# PLANNING BOARD MEETING

RE: Nitsch Project #11123.8  
Perry Estates  
Site Plan Review  
Randolph, MA

Nitsch Engineering reviewed the revised plan set for the proposed Perry Estates subdivision located at 297 Chestnut Street in Randolph, Massachusetts (the Town).

Rev. No.	Rev. Date	Description
Date: 12/20/2021		
Drawn by: JLV		
Approved by: GM		
PROPOSED CONDITIONS GRADING&DRAINAGE& EROSION CONTROL PLAN		
SCALE:		AS NOTED
SHEET 4 OF 6

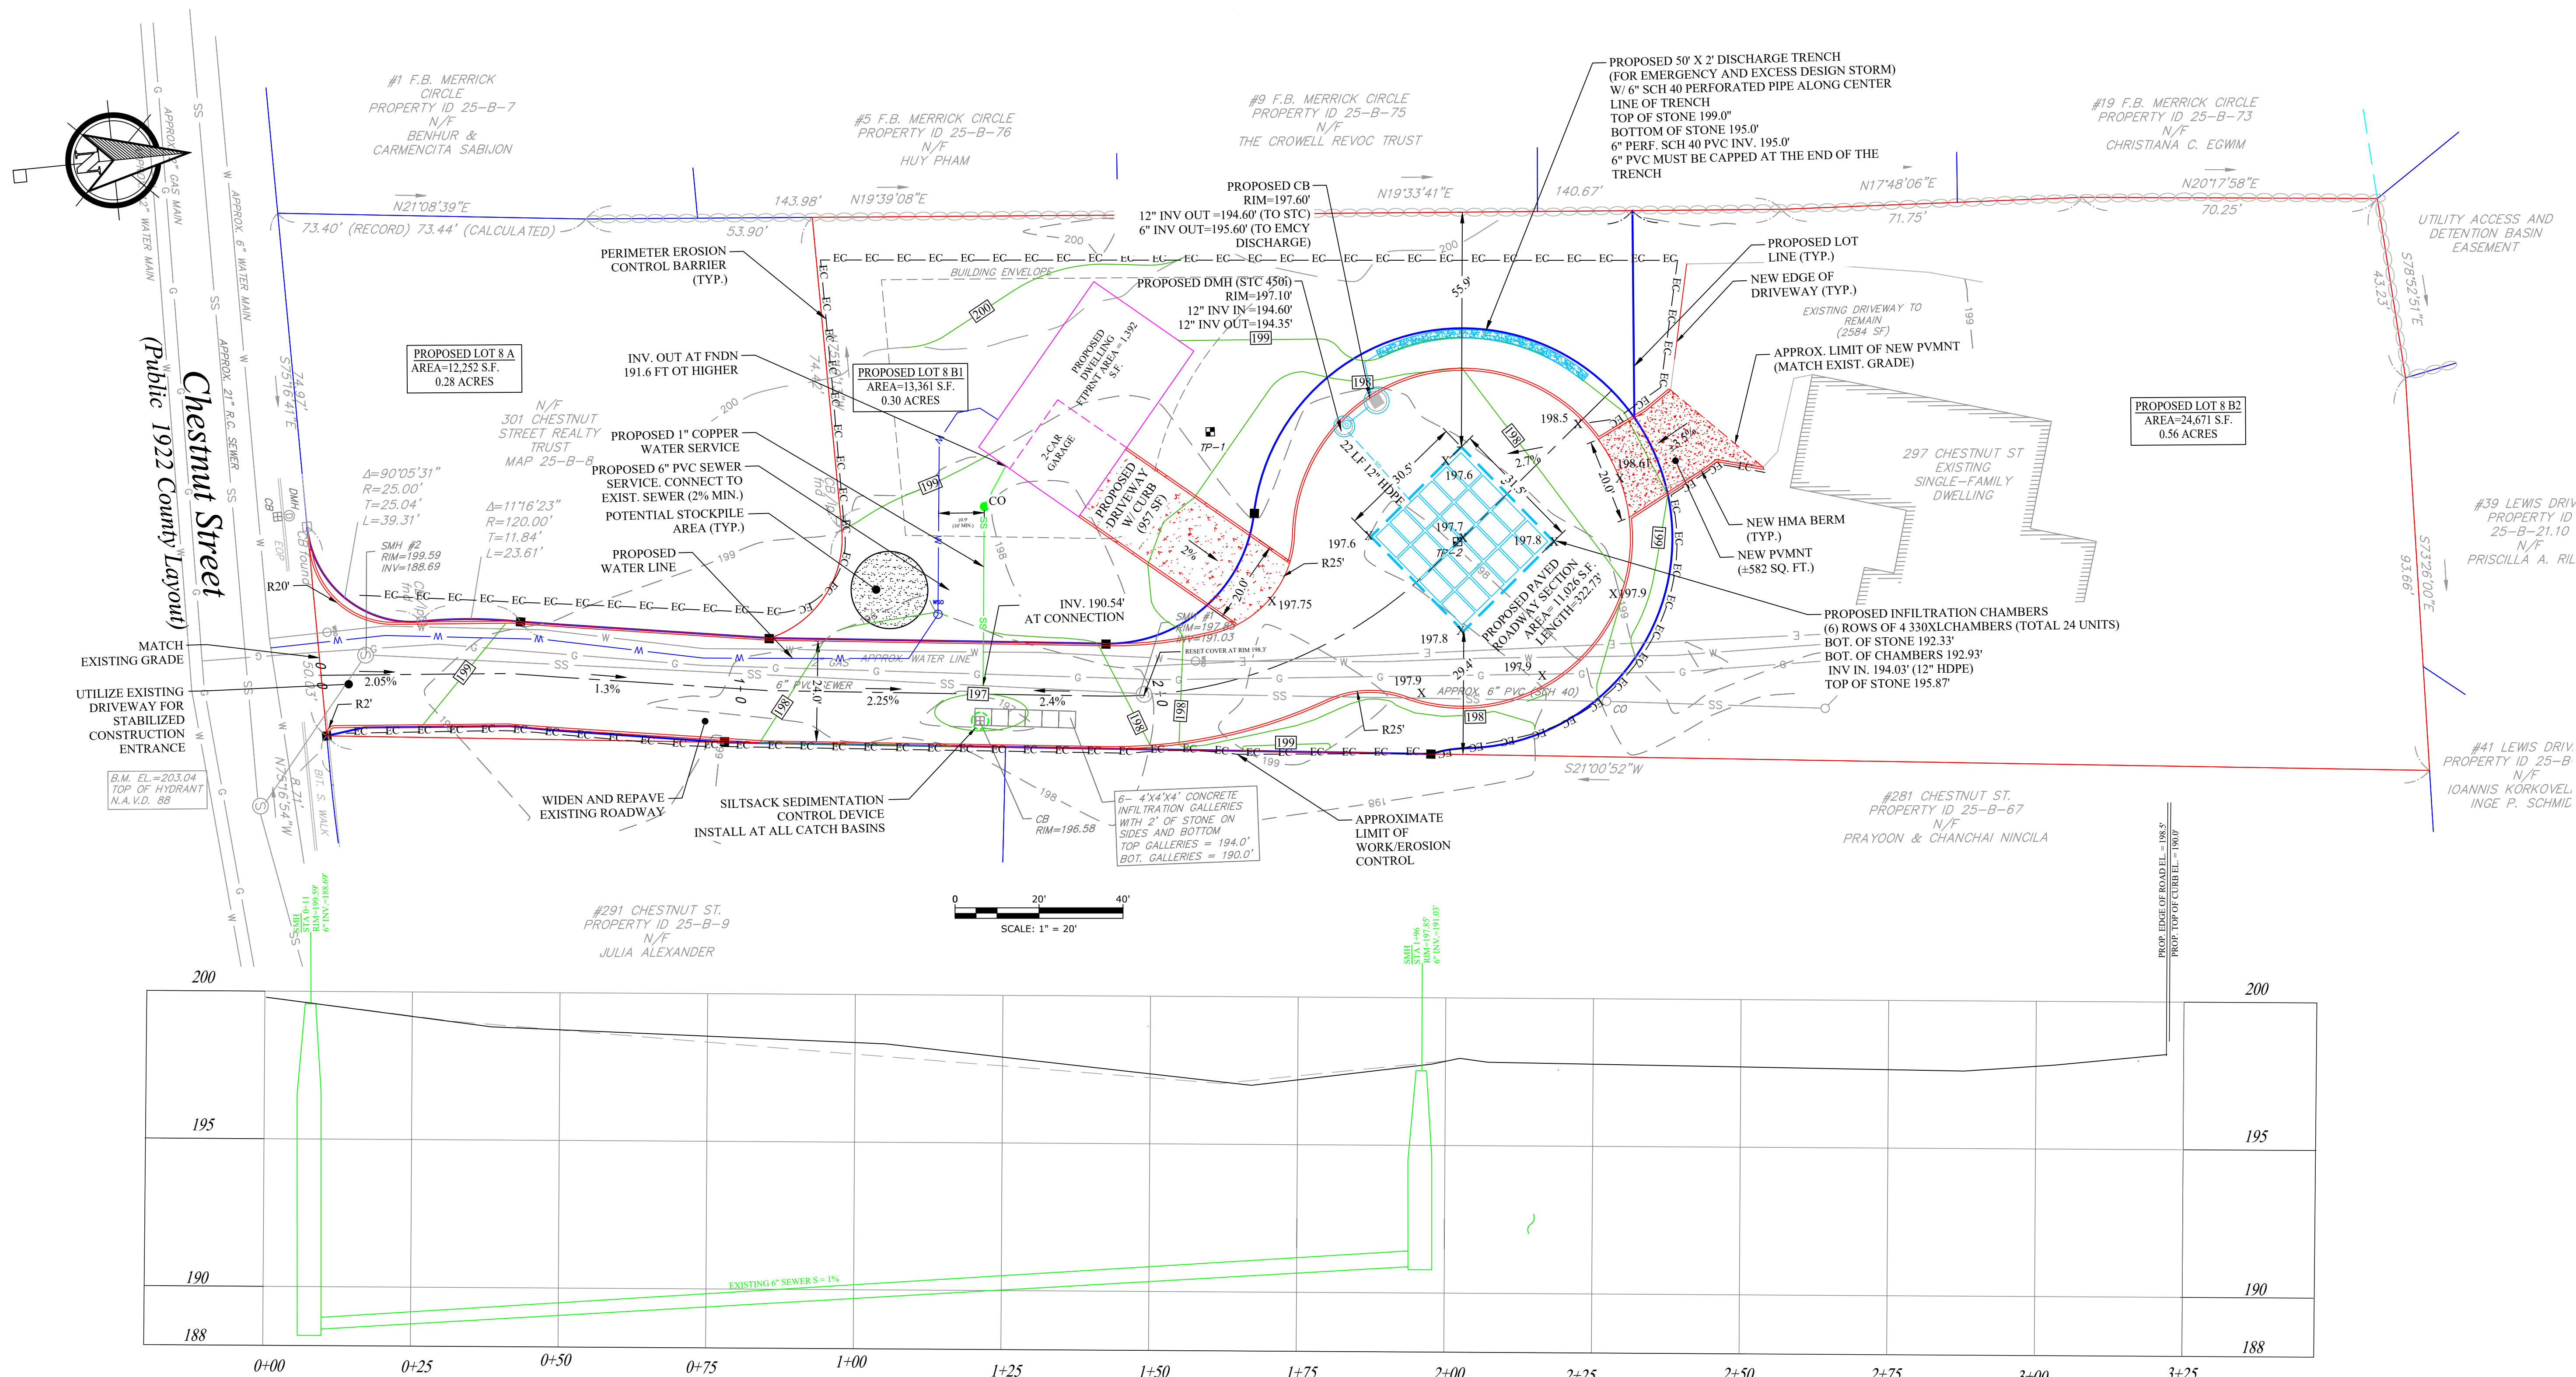
The Applicant is requesting the following waivers, which are also listed on Sheet 4 of the plan set:

1. Section VIII.B4e states that all corners of street intersections shall be rounded or cut back to provide for a minimum radius.
2. Section VIII.B5 states that ways shall be laid out to widths of forty feet (40') or fifty feet (50') based on type. Ways of greater width may be required by the Board where traffic or other considerations warrant.

29. The proposed roadway appears to travel along the eastern property line. Please refer to the Board as to whether this is acceptable.
30. Nitsch recommends the Applicant submit a curb cut detail for the driveways. The current layout does not include radii at the curb openings. The driveway for Lot 8 B1 may be difficult to access without first turning around in the cul-de-sac. Nitsch recommends the Applicant submit a vehicle turning radius diagram showing a passenger car entering from the road and pulling into the driveway of Lot 8 B1.

12" STORM DRAIN PIPE TRENCH DETAIL  
NOT TO SCALE

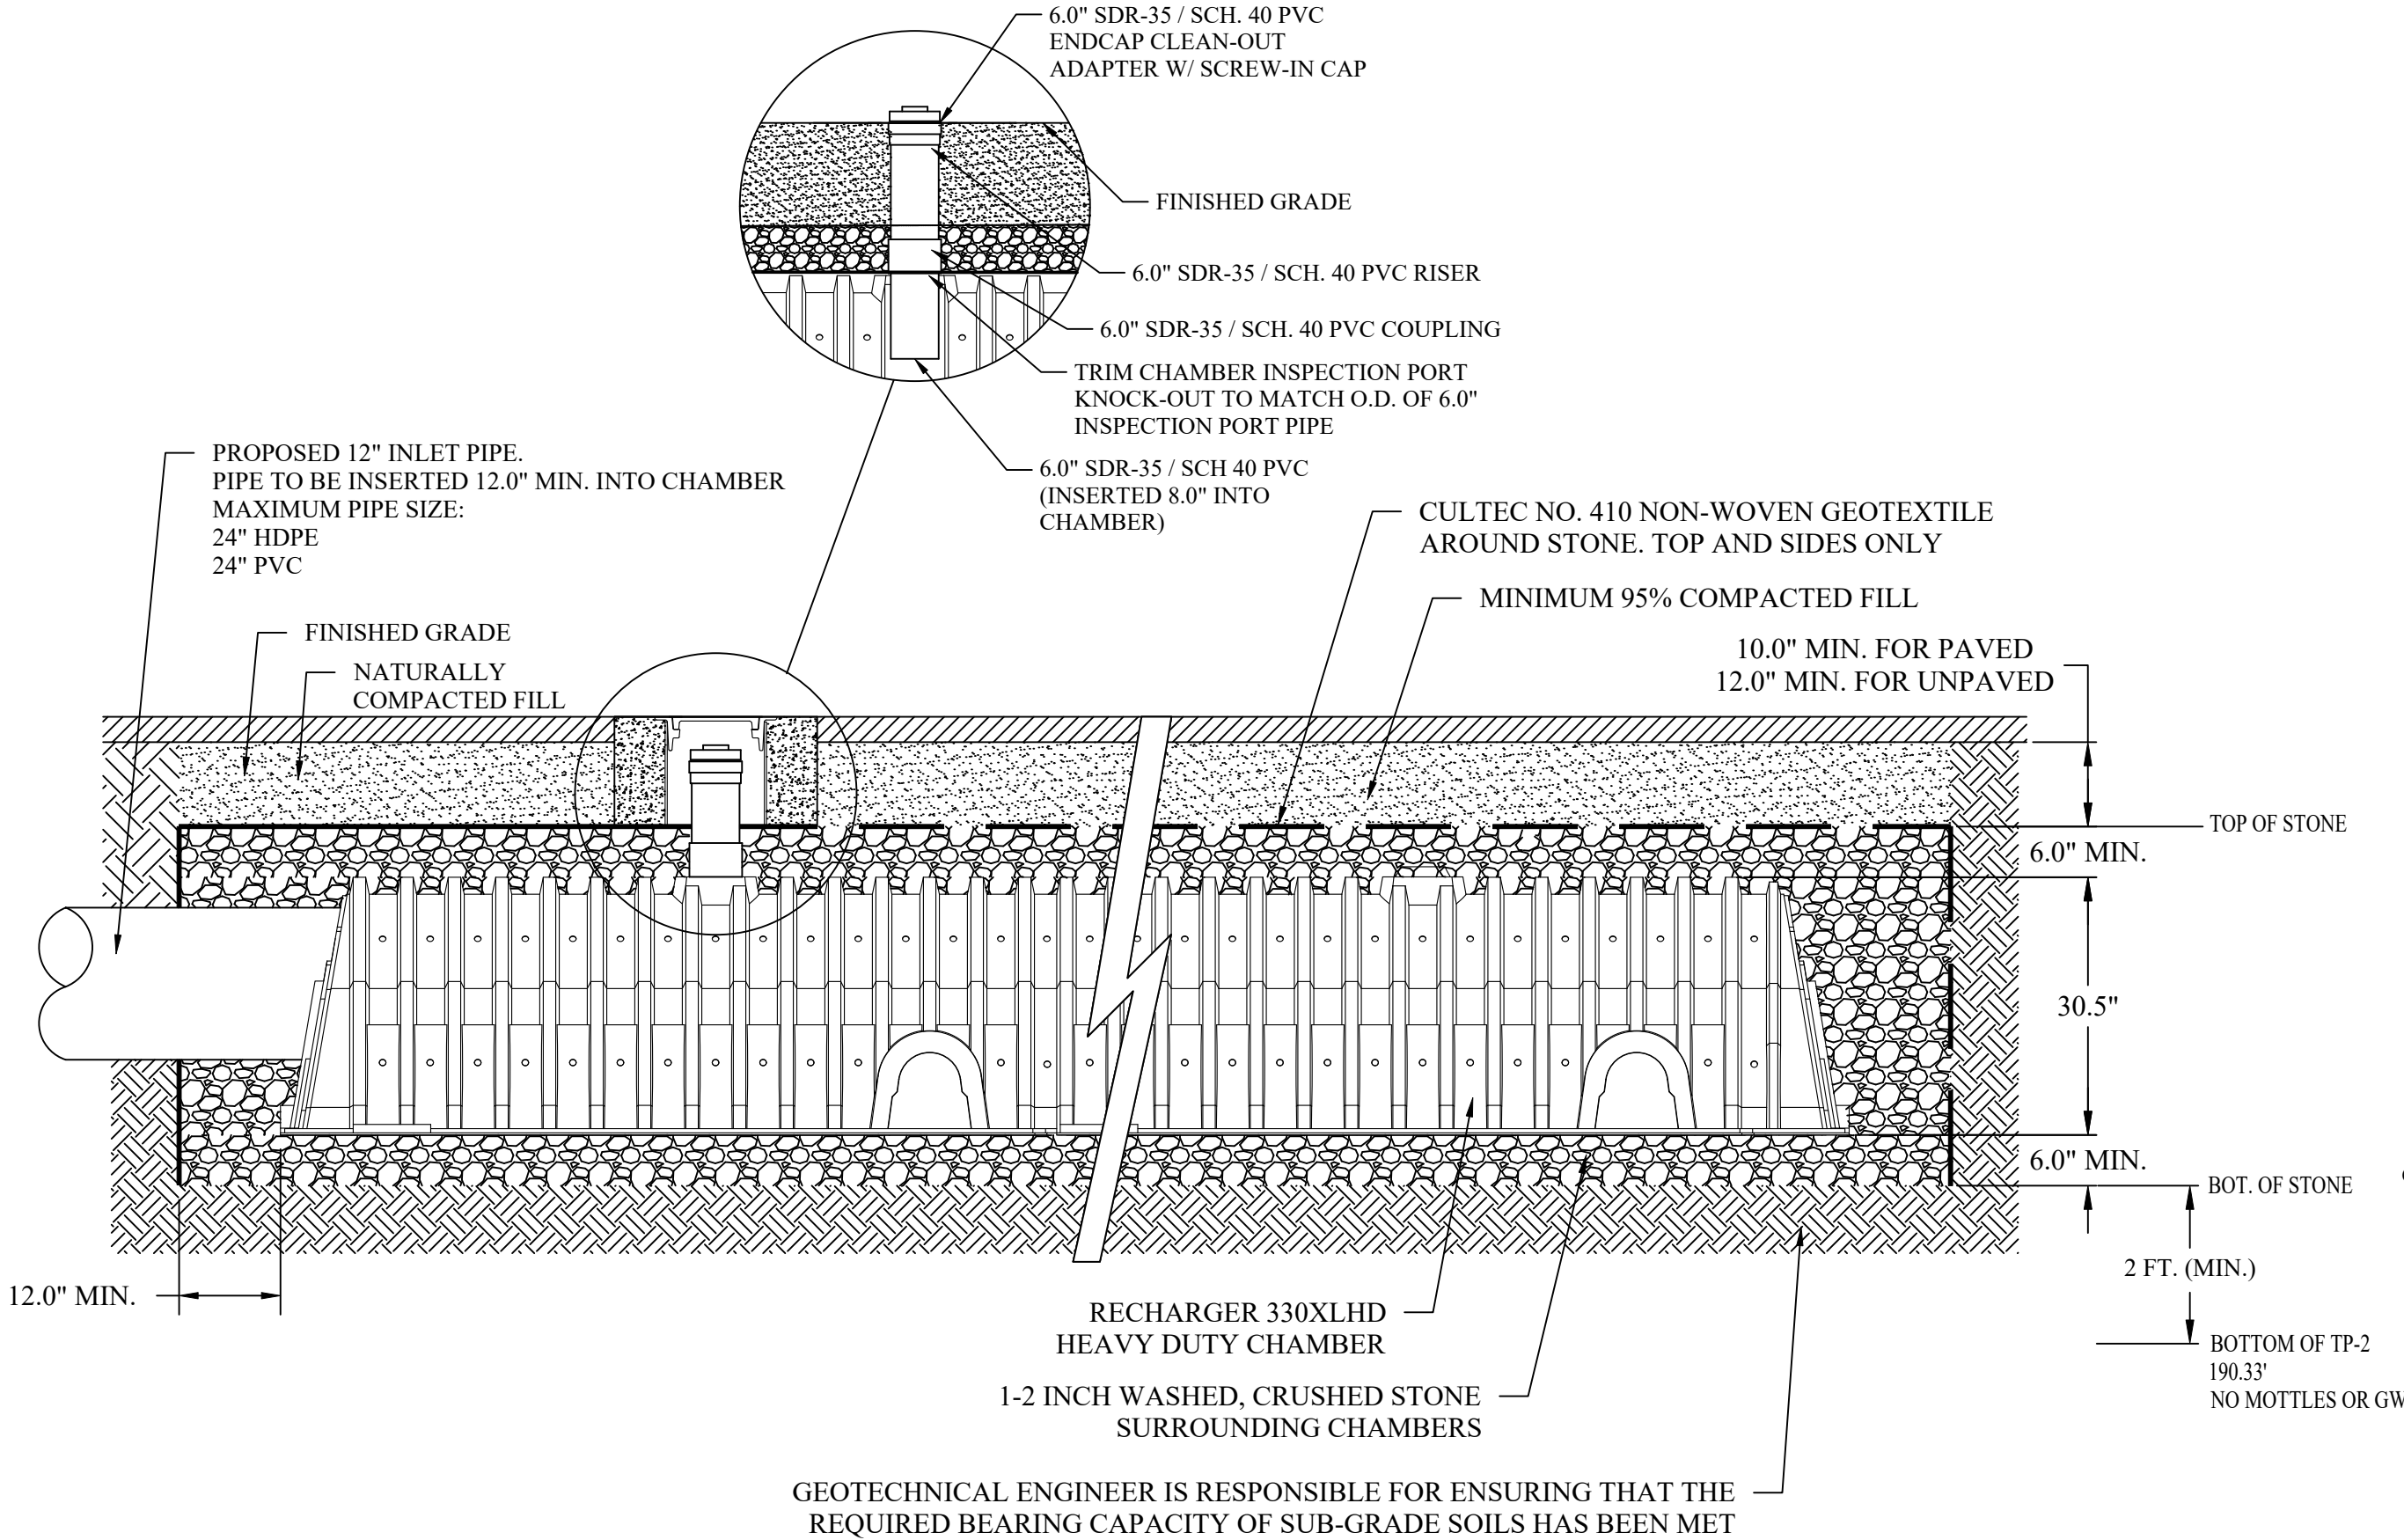
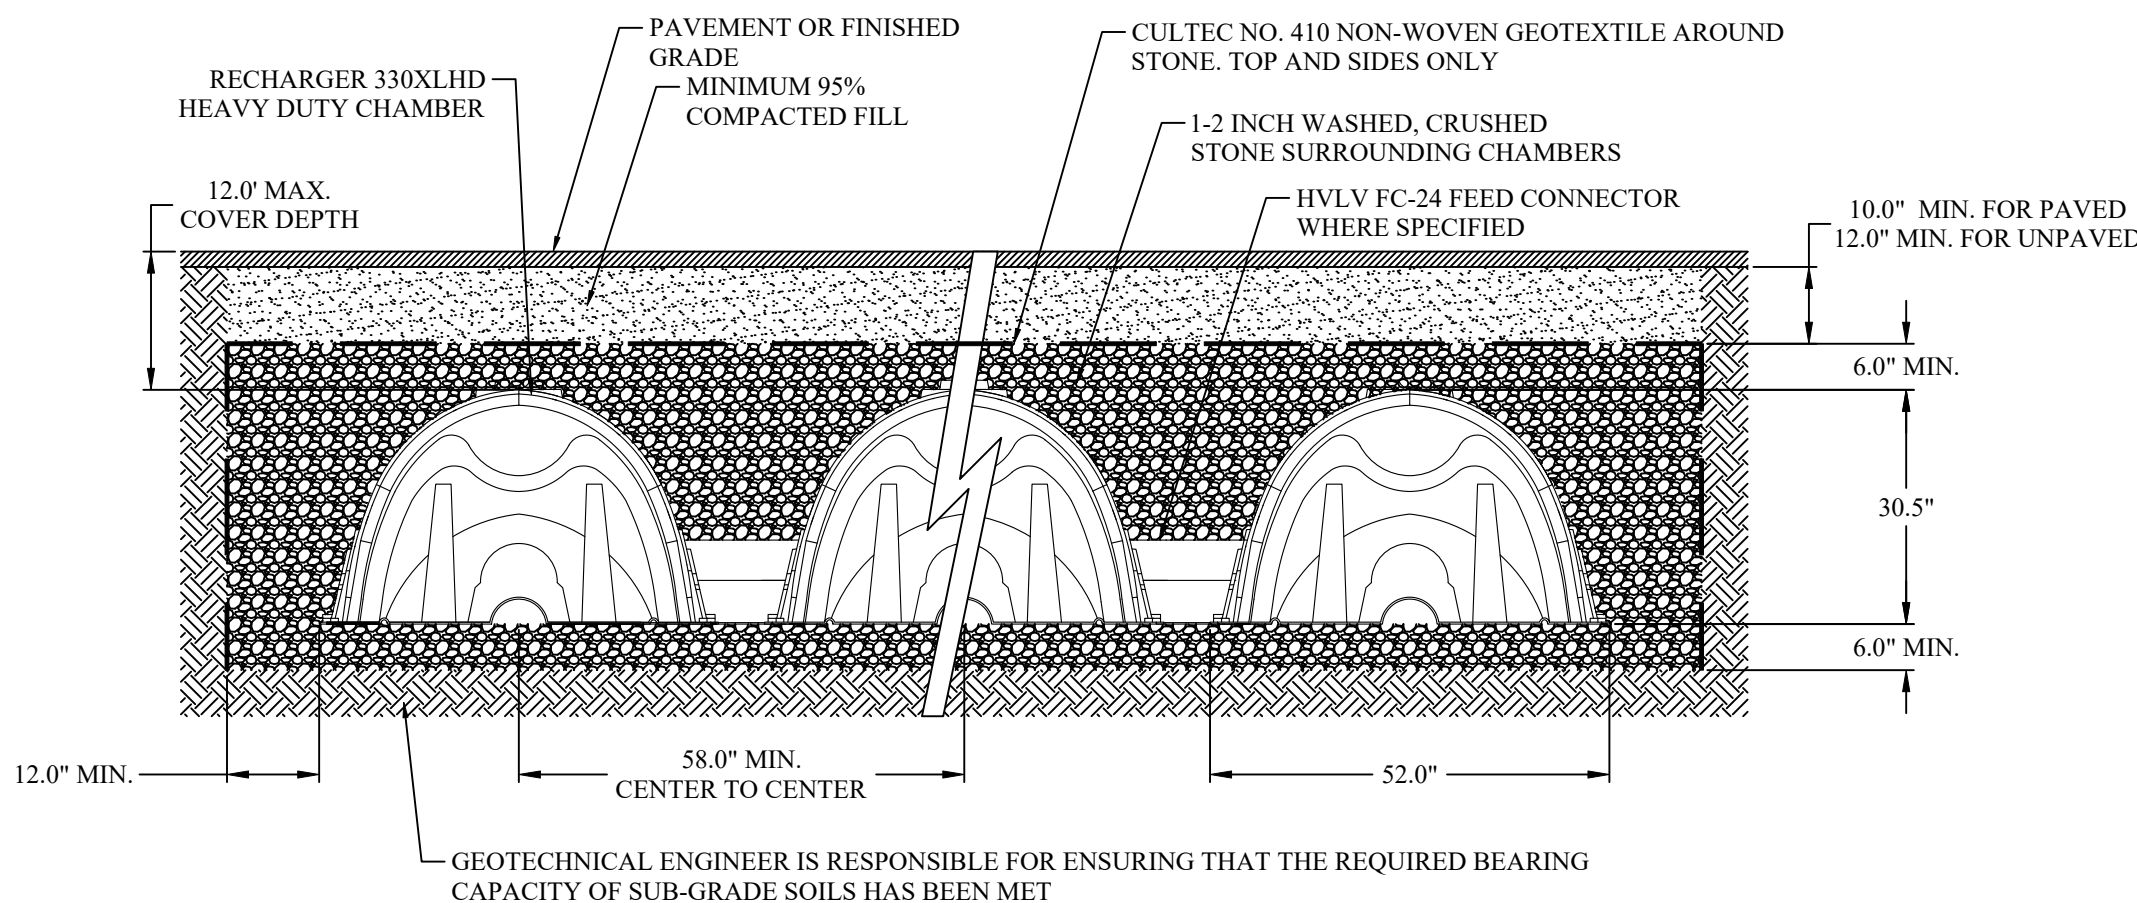
8. Section VIII.D12 states that the full length of pipe, except the bell, must rest upon undisturbed soil except as hereinafter specified. The '*12" storm drainpipe trench detail*' on Sheet 5 shows the pipe laid on 6" of  $\frac{3}{4}$ " crushed stone. Nitsch recommends the Applicant revise the detail to show the pipe resting on undisturbed soil or explain why the 6" of crushed stone is better suited for design. In addition, there does not appear to be 12" drainpipes used in the design, therefore, Nitsch recommends updating the detail to reflect the size of pipes used in the design.
